**COMMANDER 114 SERIES
SERVICE PUBLICATIONS**

The following is a numerical list of all active Service Bulletins.

SERVICE BULLETIN NO. SB-114-1

AILERON CONTROL CHAIN REROUTING

Figure 2.

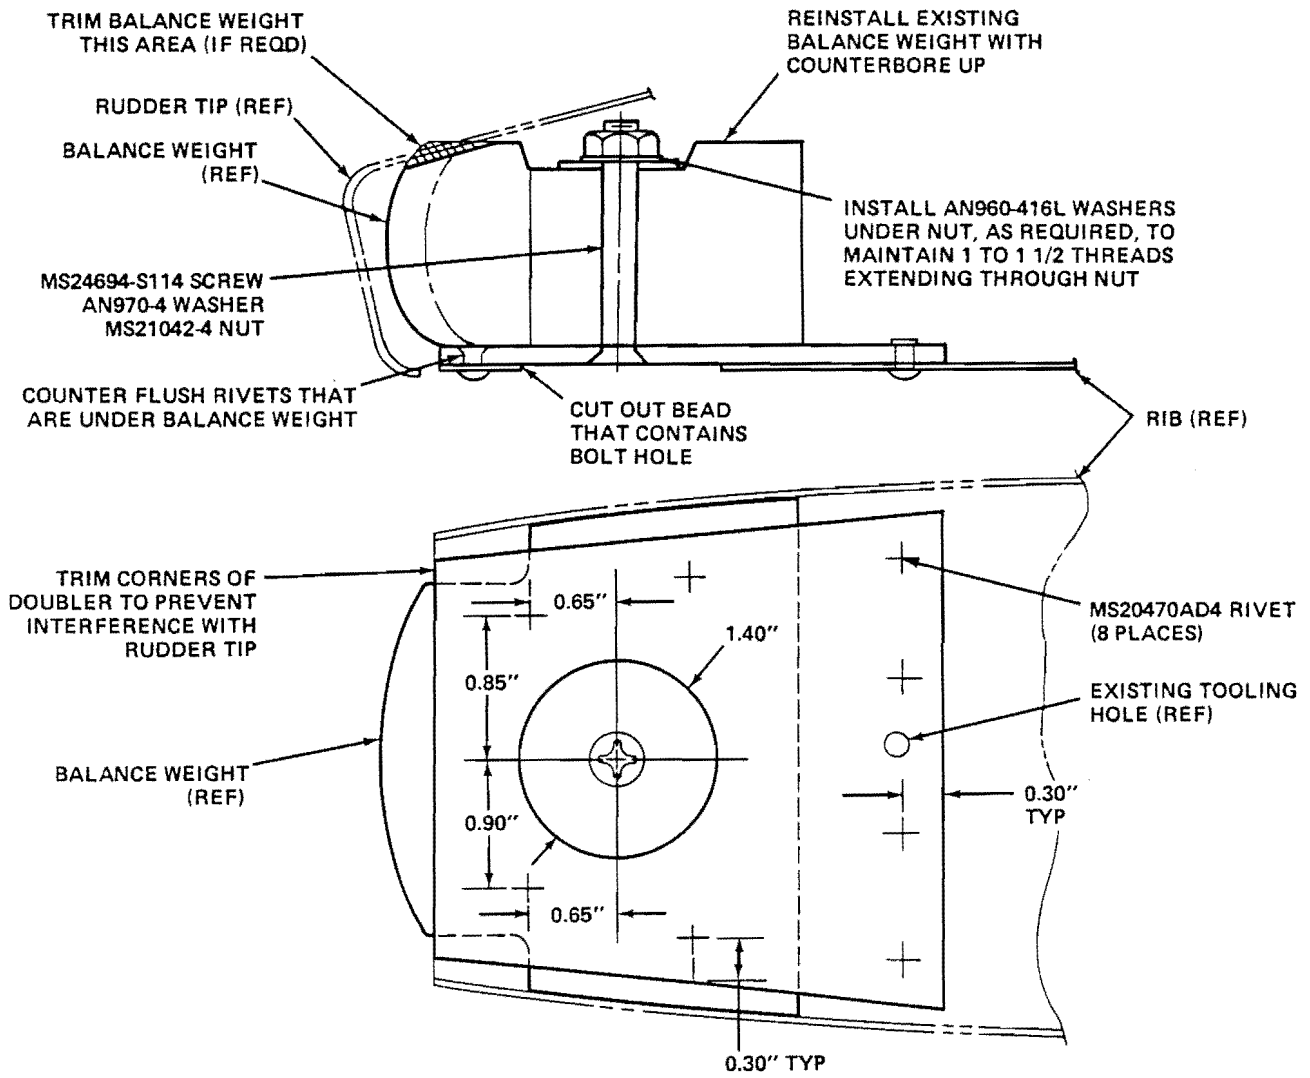
1. Remove rudder assembly from airplane as outlined in Section 7 of the Airplane Maintenance Manual.
2. Remove balance weight from rudder tip rib.
3. Fabricate a doubler from 0.125-inch, 2024-T3 clad aluminum sheet (refer to Figure 2).

4. Position fabricated doubler on bottom side of rudder rib, insert MS24694-S114 screw in rib bolt hole and in doubler hole (for hole alignment) and then locate and drill rivet attach holes in doubler and in rib (refer to Figure 2).

5. Remove doubler from rib and cut out bead (dimpled area) from rudder rib. Smooth cutout by using #400 grit emery cloth (refer to Figure 2).
6. Countersink holes in top side of fabricated doubler where balance weight installs over doubler. Countersink is for counter flushing MS20470AD4 rivets on top of doubler.

10. Install fabricated doubler on top side of rudder tip rib using MS20470AD4 rivets. Rivet heads are to be on lower side of rib. Counter flush four (4) rivets in area under balance weight (refer to Figure 2).

11. Reinstall existing balance weight on rudder tip rib, with counterbore up, using MS24694-S114 screw, existing AN970-4 washer and MS21042-4 nut. Torque nut 30 to 40 inch-pounds (refer to Figure 2).
12. Trim balance weight to assure clearance between rudder tip and weight (refer to Figure 2).
13. Reinstall tip on rudder using existing hardware.
14. Touchup paint, as necessary, on rudder assembly.
15. Check balance of rudder assembly as follows (refer to Figure 3):

Figure 3.

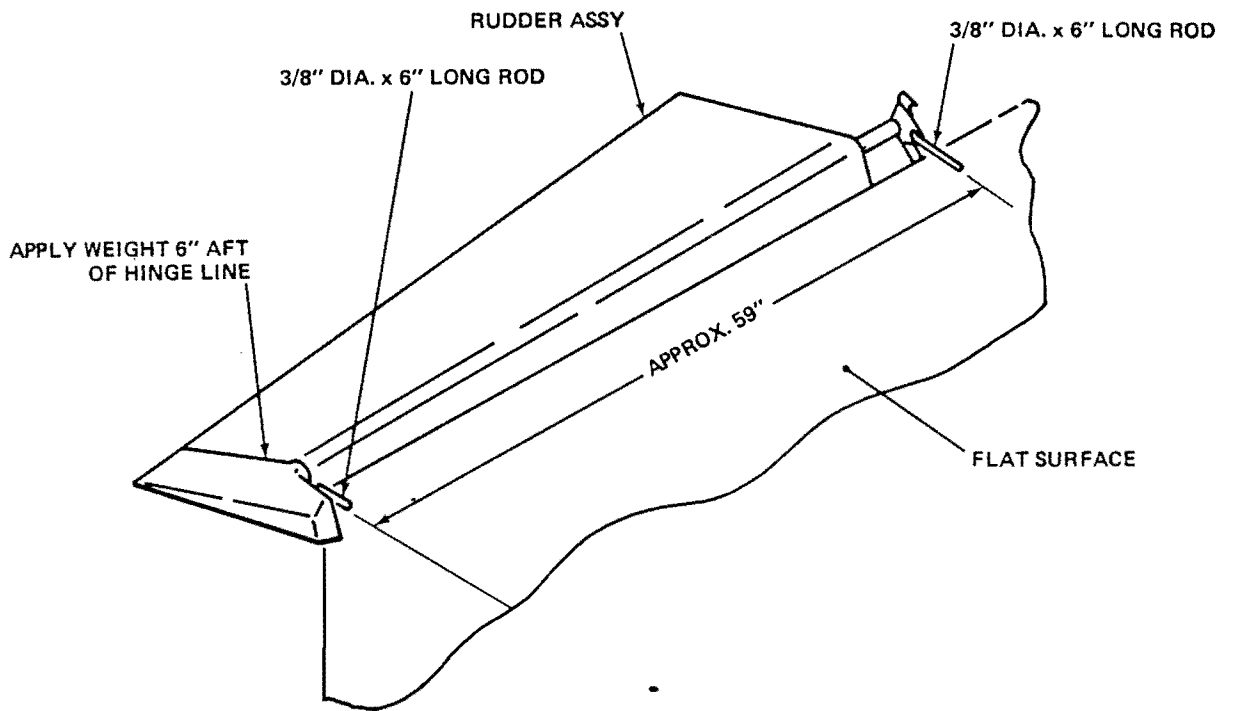
- b. Slide 1/4-inch diameter bolts through upper and lower hinges and tighten with jam nuts.
- c. Position rudder over rods so that bolts rest on rods.
- d. Apply up to 1-pound of weight 6-inches aft of rudder hinge line at lower edge of rudder tip. Rudder should be balanced (level).
- e. If more than 1-pound of weight is applied in order to balance rudder, trim rudder balance weight, as necessary, to balance rudder with 1-pound or less weight applied 6-inches aft of hinge line.

Figure 1.

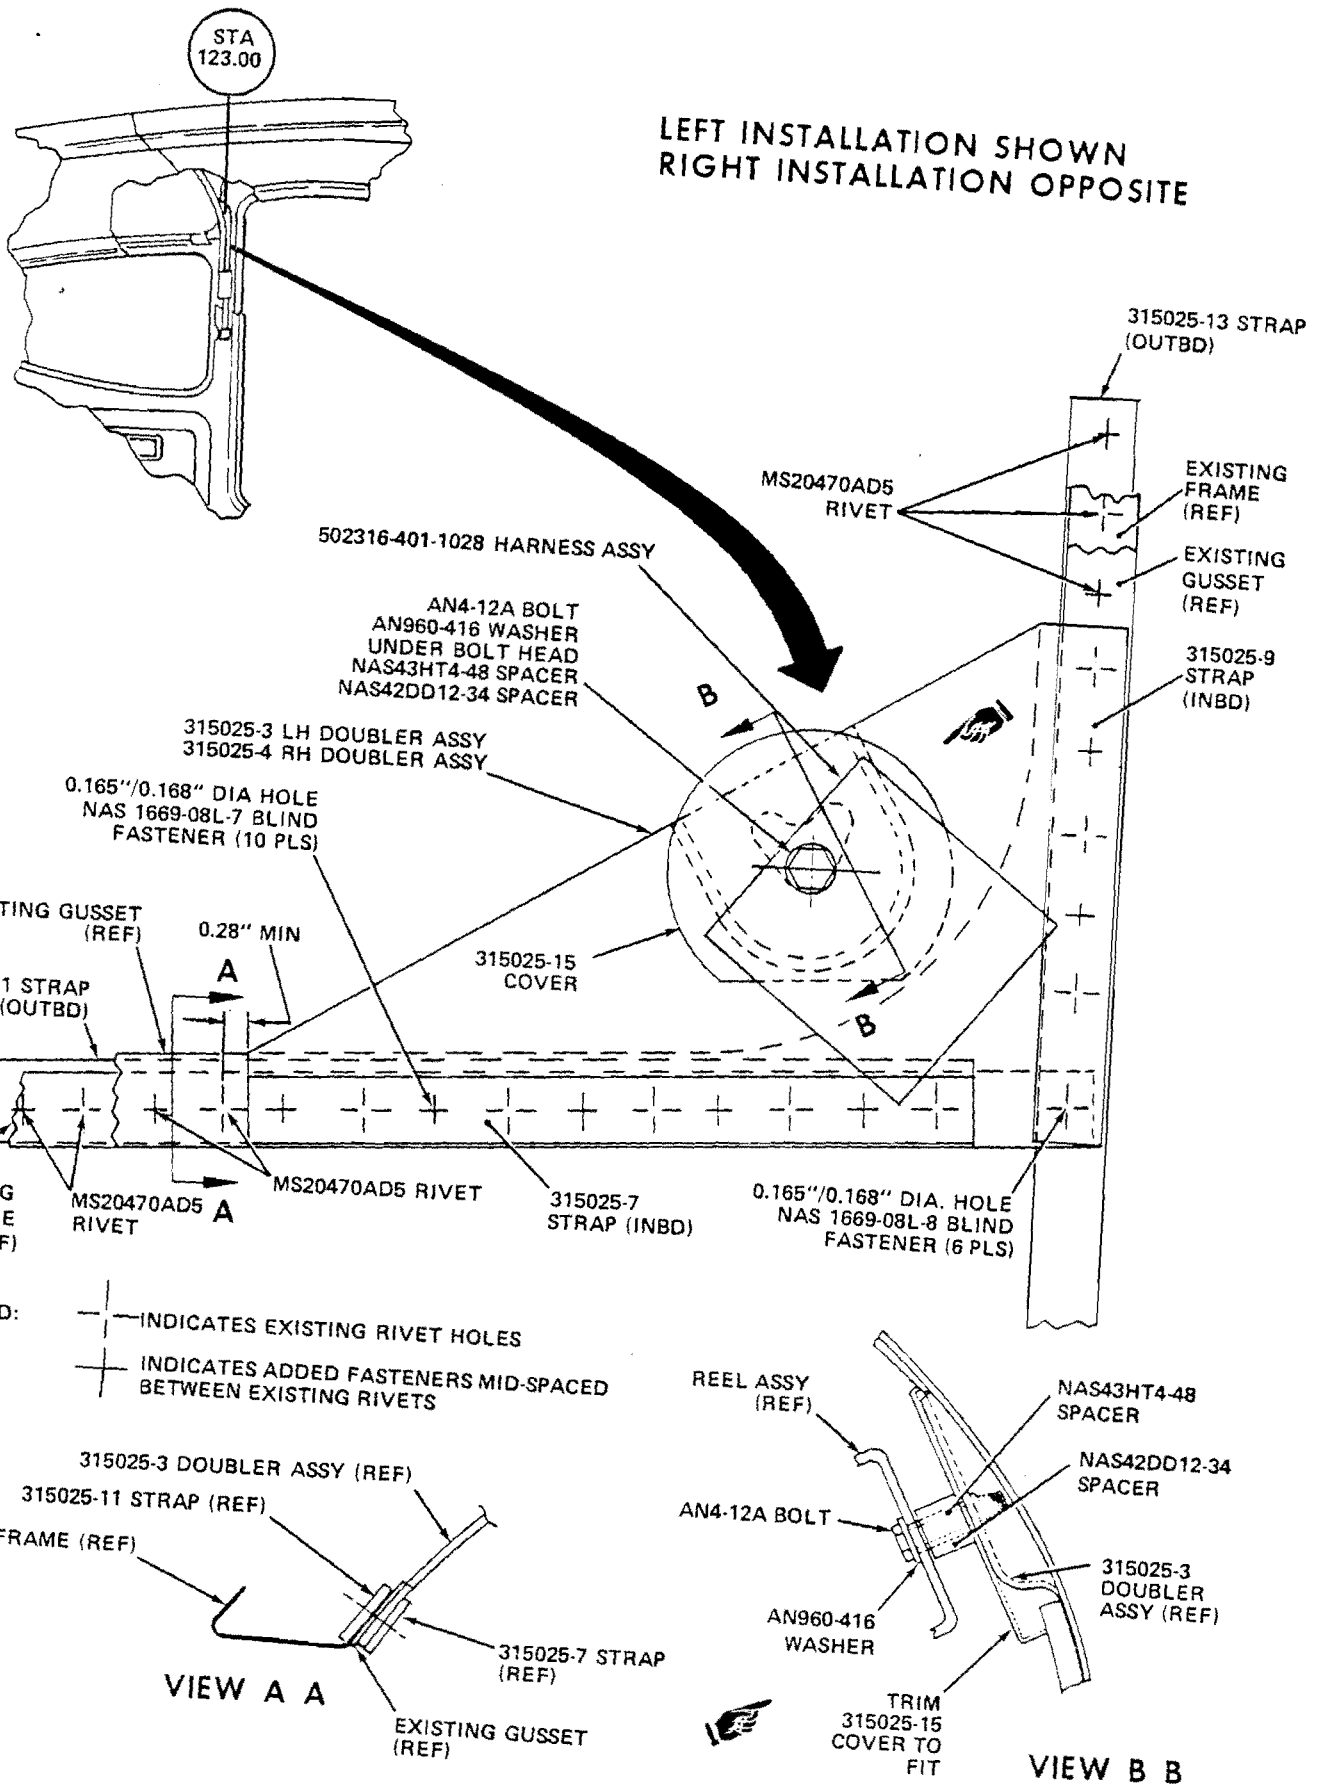
4. Drill out rivets in left and right aft door frame and upper window frame, as necessary, for installation of 315025-3 and 315025-4 doubler assemblies (refer to Figure 1).

5. Locate, drill and install 315025-3 and 315025-4 doubler assemblies, 315025-7 strap, 315025-9 strap, 315025-11 strap and 315025-13 strap (refer to Figure 1).

8. Reinstall left and right interior side panels using existing hardware.
9. Install 315025-15 cover on 315025-3 and 315025-4 doubler assemblies using EC 1403 cement or equivalent. Trim 315025-15 cover, as necessary, to fit (refer to Figure 1).

- c. Reinstall shoulder harness reel assembly using AN4-12A bolt, existing AN960-416 washer, NAS43HT4-48 spacer and NAS42DD12-34 spacer (refer to Figure 1).

Figure 2.

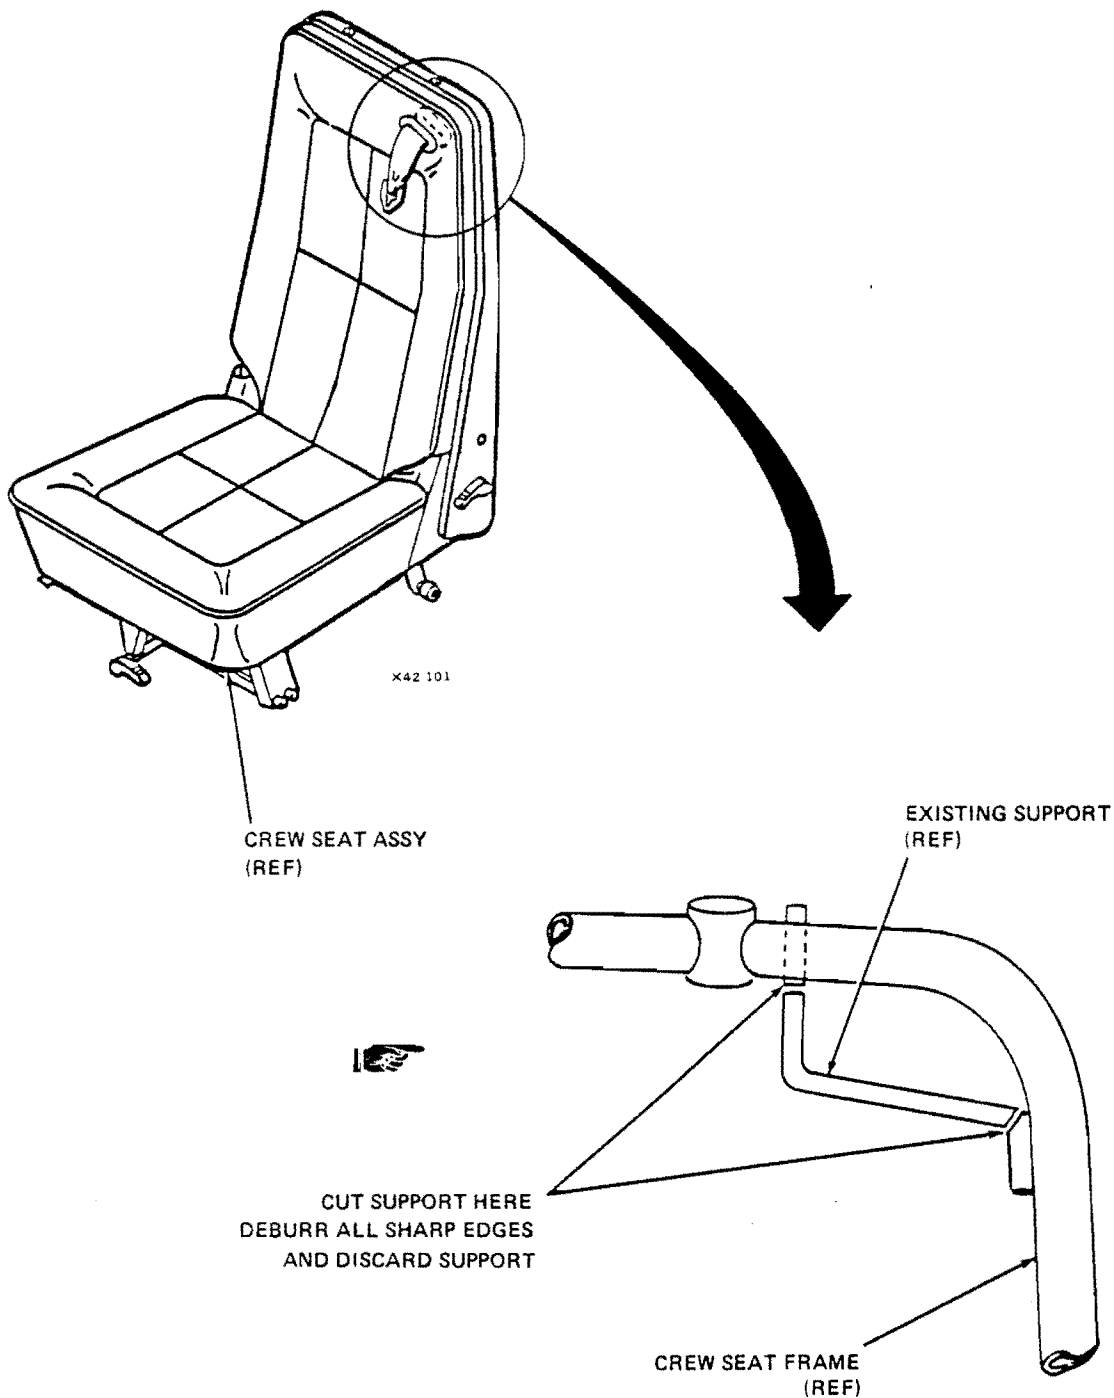
- e. Rework seat frame assembly by cutting away existing seat belt support (refer to Figure 2).
 - f. Remove and discard aft roller assemblies, and remove forward roller assemblies and retain for reinstallation.

- d. Remove seat back shroud, if necessary, to facilitate removal of existing shoulder harness support.
 - e. Remove and discard existing shoulder harness support from seat frame (refer to Figure 2).

Figure 4.

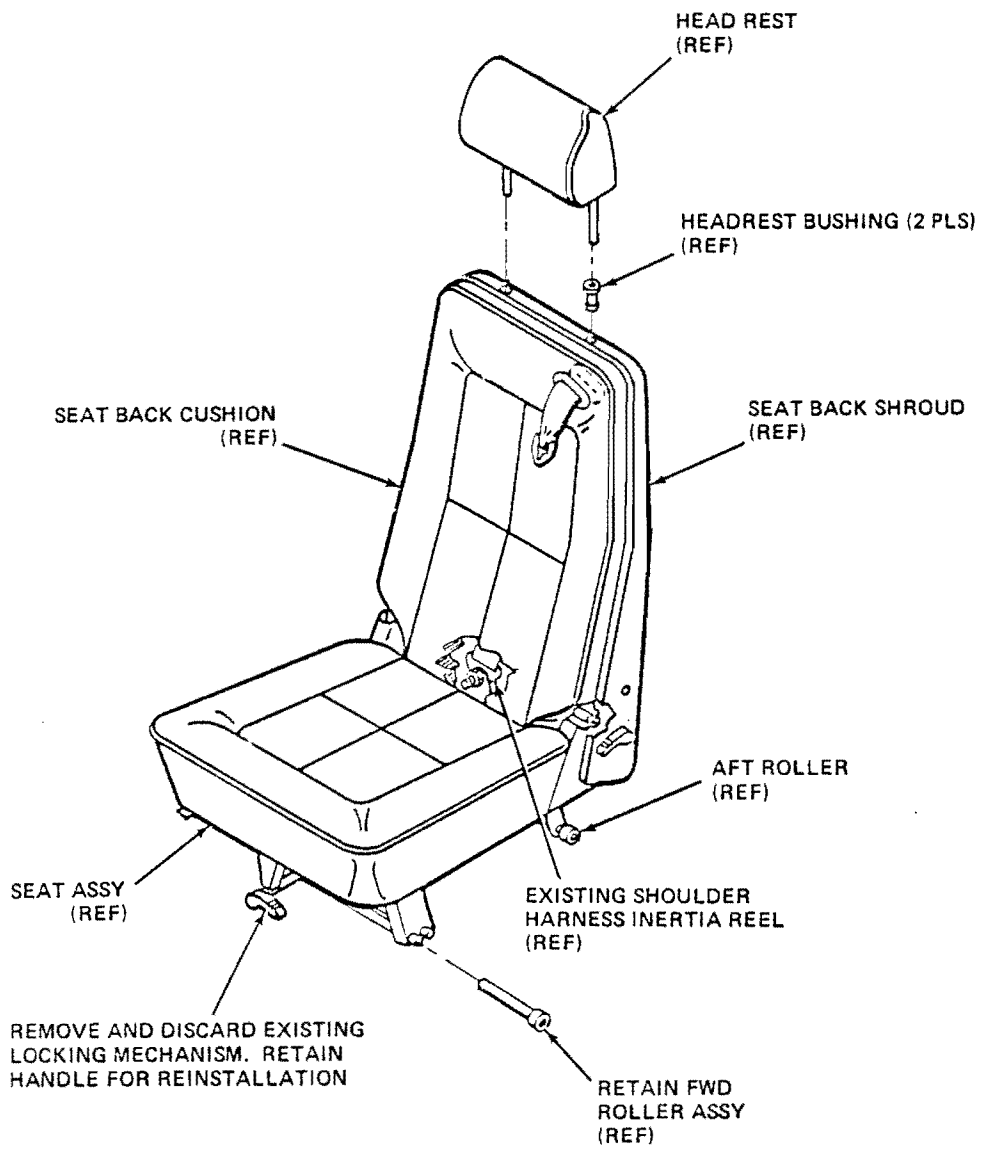
- a. Remove seat headrest and remove seat back shroud by carefully prying up on plastic headrest bushing flanges (refer to Figure 4).
 - b. Remove roll pins attaching forward seat back adjustment handle and discard roll pin.

- c. Remove and discard existing shoulder harness inertia reel assembly and attaching hardware (refer to Figure 4).
 - d. Remove seat back cushion by pulling forward on cushion and lifting up (refer to Figure 4).

- g. Remove and discard existing forward seat locking mechanism. Retain handle for reinstallation on new seat locking mechanism (refer to Figure 4).
 - h. Modify seat frames as shown in Figure 5.

- a. Remove head rest from seat assembly.
 - b. Remove existing 49082-5 guide cover from forward side of seat cushion (refer to Figure 7).
 - c. Remove seat back cushion by pulling forward on cushion and lifting up (refer to Figure 4).

Figure 6.

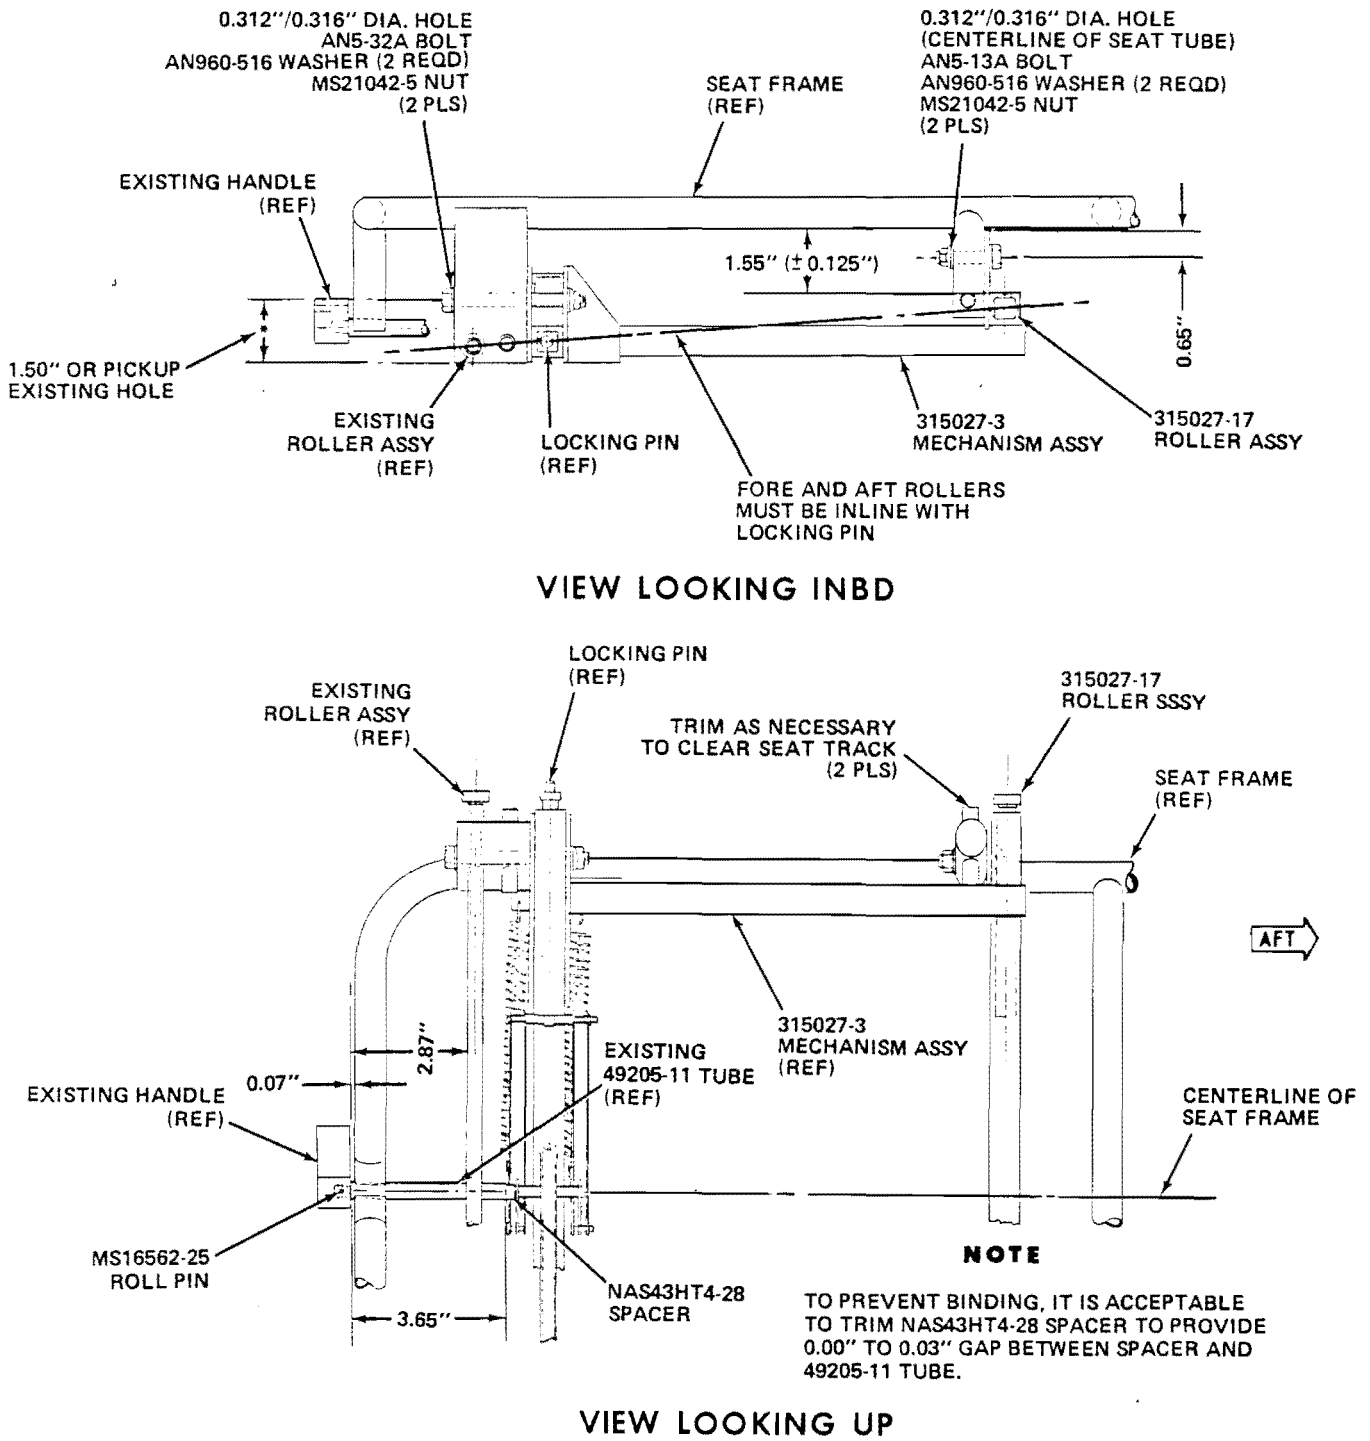
- i. Trim existing 49205-11 tube to dimensions shown in Figure 6.
 - j. Paint bare metal on seat structure with zinc chromate primer and repaint seat structure as necessary.

- k. Install NAS43HT4-29 spacer on 315027-3 mechanism assembly shaft (refer to Figure 6).
 - l. Install 315027-3 mechanism assembly on seat structure by inserting mechanism shaft into shaft tube and pushing mechanism assembly forward (refer to Figure 6).

- m. Drill holes in 315027-3 mechanism assembly and existing seat structure and install attaching hardware (refer to Figure 6).
- n. Drill and install existing handle on 315027-3 mechanism assembly using MS16562-25 roll pin (refer to Figure 6).
- o. Locate and cut a 0.40-inch by 2.45-inch slot in seat back shroud for routing of shoulder harness (refer to Figure 7).
- p. Reinstall seat back shroud and plastic headrest bushings.
12. Insert shoulder harness through inertia reel boot, one (1) 49082-5 guide cover, cutout in seat back shroud, 315027-37 spacer(s), 49081-1 guide, seat cushion and through the other 49082-5 guide cover and then lock into place with 49082-5 guide covers (refer to Figure 7).

13. Install existing forward roller assemblies on 315027-3 mechanism assembly (refer to Figure 6).
14. Install 315027-17 roller assemblies on 315027-3 mechanism assembly (refer to Figure 6).
